**TRANSMITTAL OF THE ACTION MEMORANDUM ADDENDUM FOR THE C-410
INFRASTRUCTURE REMOVAL AT THE PADUCAH GASEOUS DIFFUSION PLANT,
PADUCAH, KENTUCKY (DOE/LX/07-0273&D2)**

**Action Memorandum Addendum
for the C-410 Infrastructure Removal
at the Paducah Gaseous Diffusion Plant,
Paducah, Kentucky**

Subject: Change in Scope of Removal Action
Action Memorandum

Date: November 2009

Figure 1. C-410 Location Map

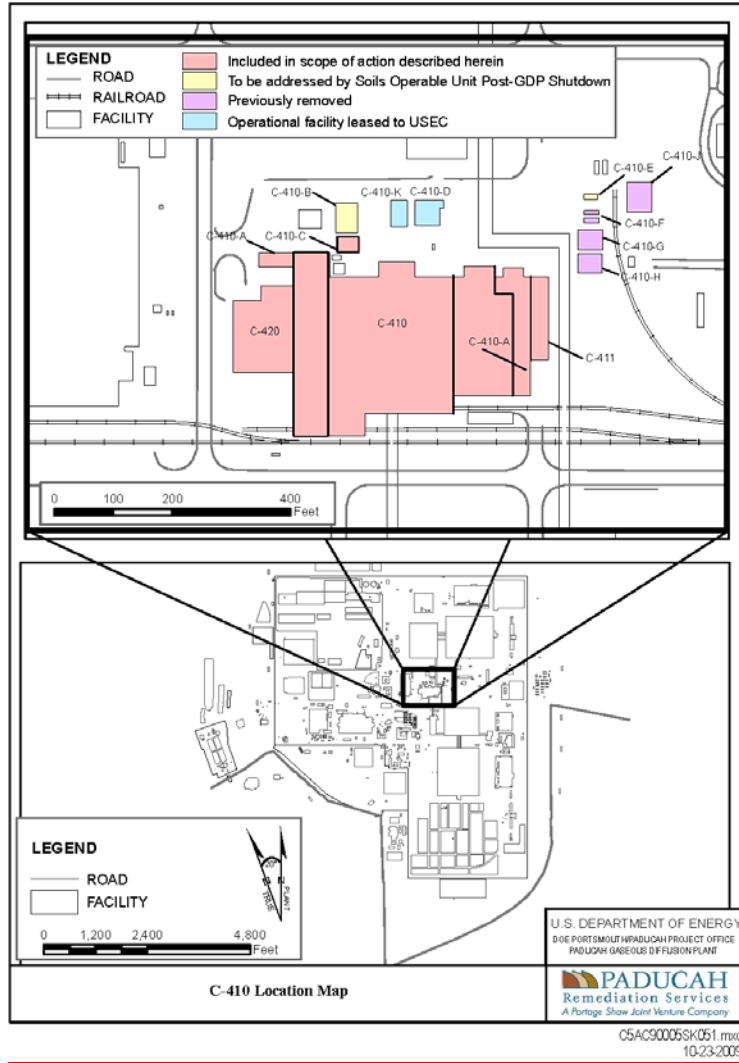
Comment [EPA1]: Include revised Fig 1.
